AGENDA - TROY PLANNING COMMISSION MEETING
WEDNESDAY, MARCH 25, 2026, 3:30 P.M.
CITY HALL, COUNCIL CHAMBERS

SUBJECT: Certificate of Appropriateness (COA) – 14 N. Walnut St

SUBJECT: Certificate of Appropriateness – 9/11 E. Main Street

SUBJECT: Certificate of Appropriateness – 16 S. Market Street

Figure A.1

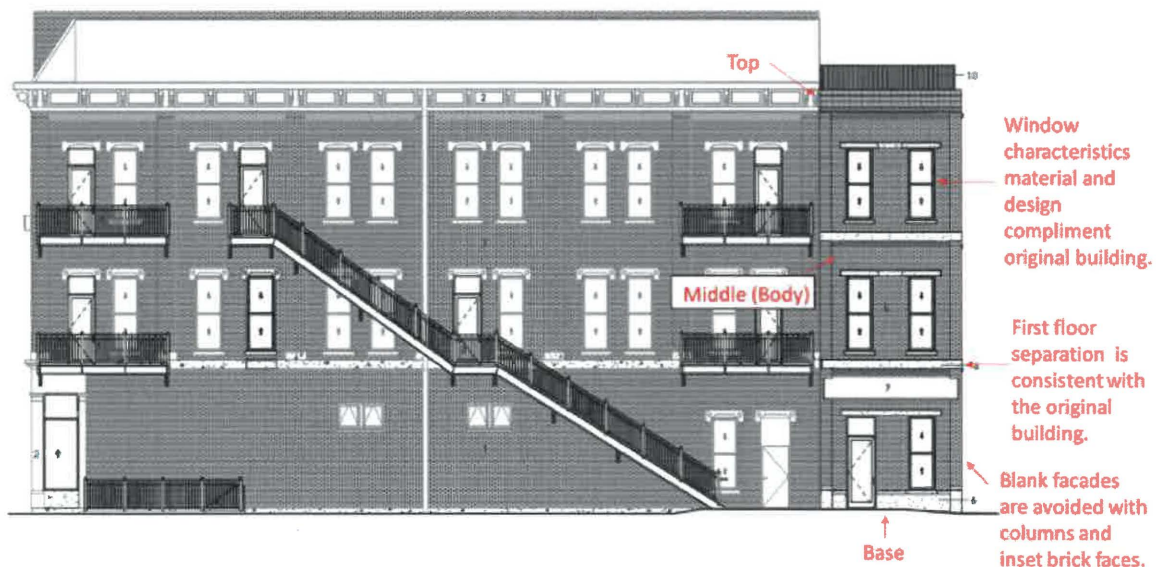
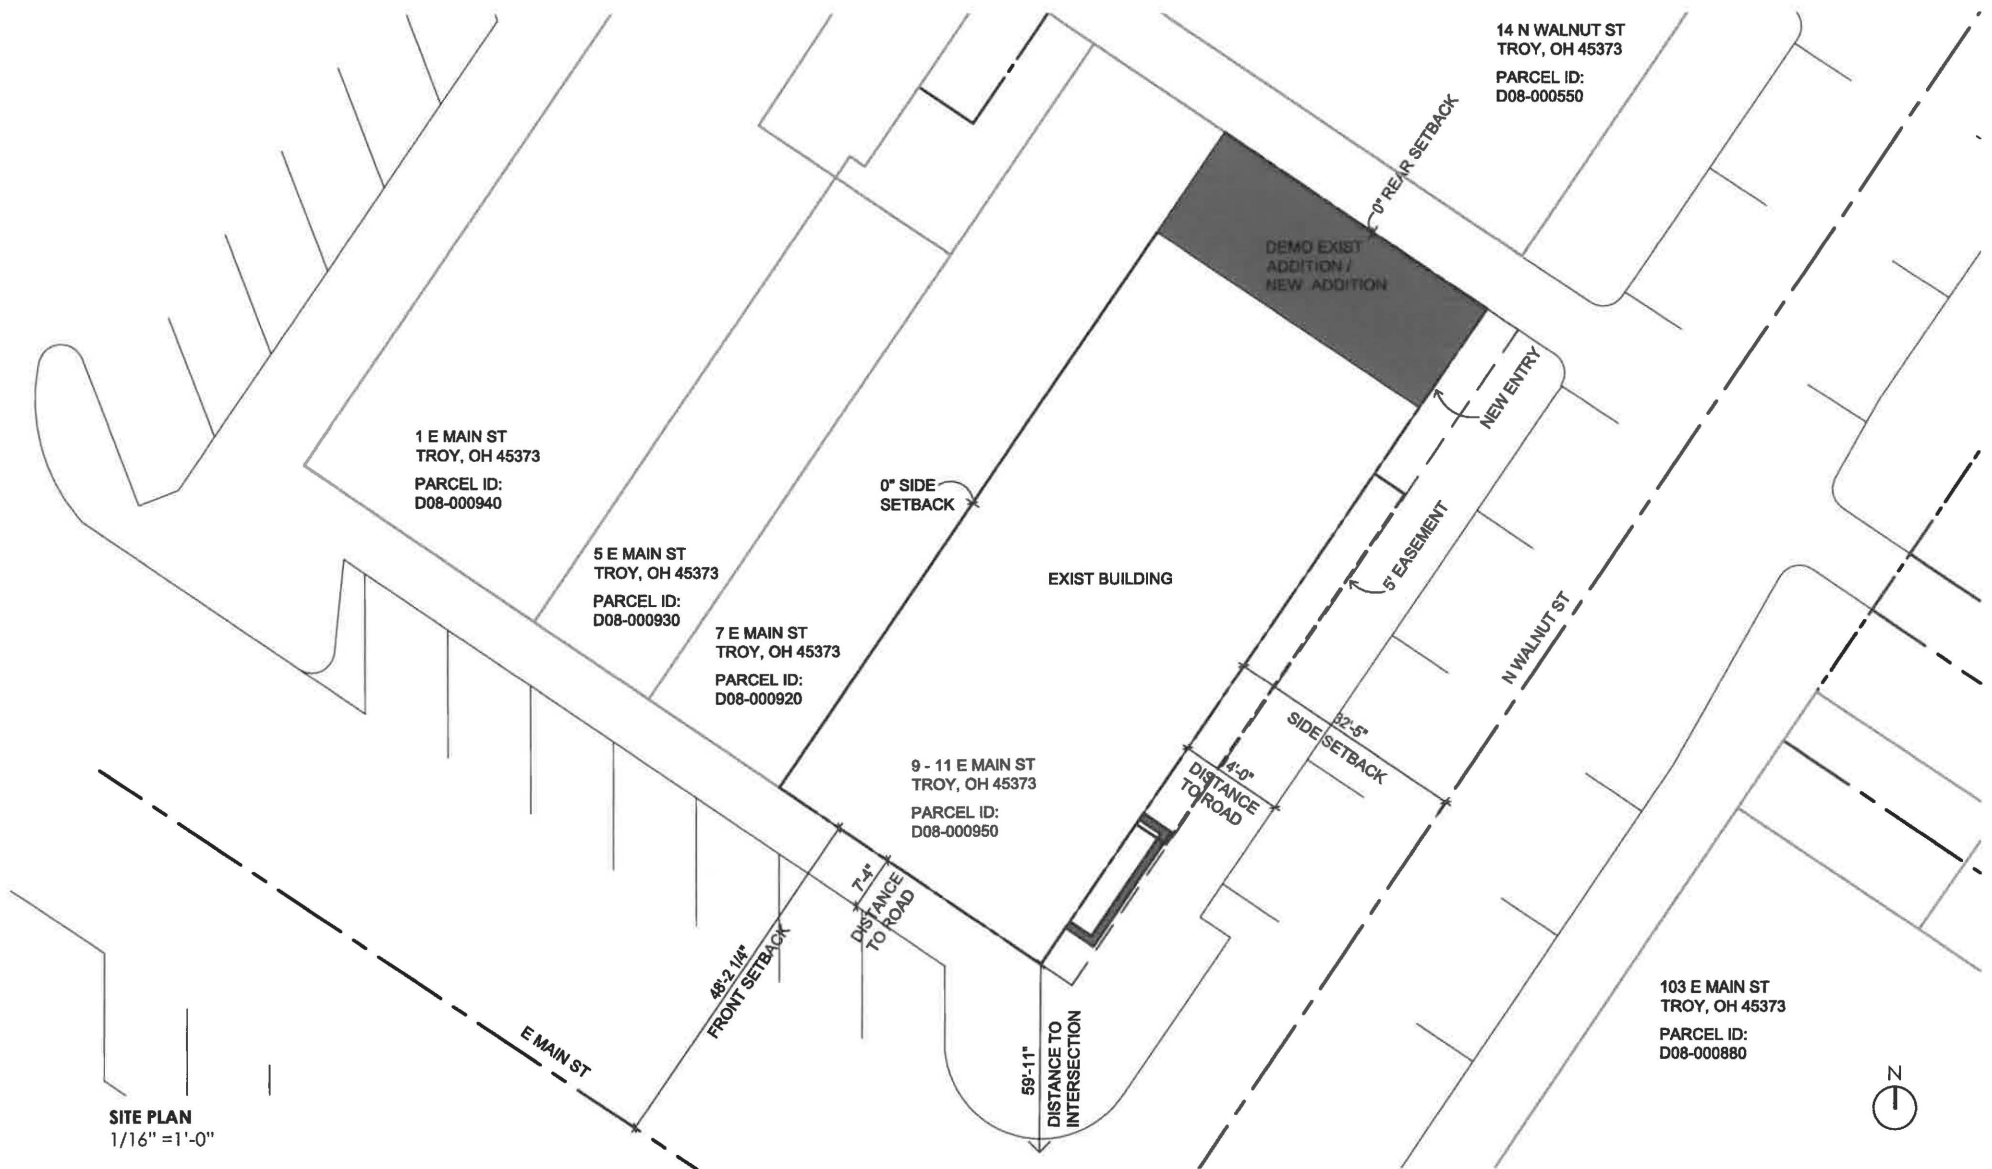
The proposed building meets the above standards. The height, mass, and design match the original building. The continuity of the original building is continued through the addition. The first-floor separation is carried through. Please see visual example in Figure A.1 below:

The pattern and proportions of window and door openings are proportional to the original building. The addition incorporates double hung windows that functionally operate the same as the original building, with similar sizing and separation. The window to wall ratios also matches the original building. See figure A.1.
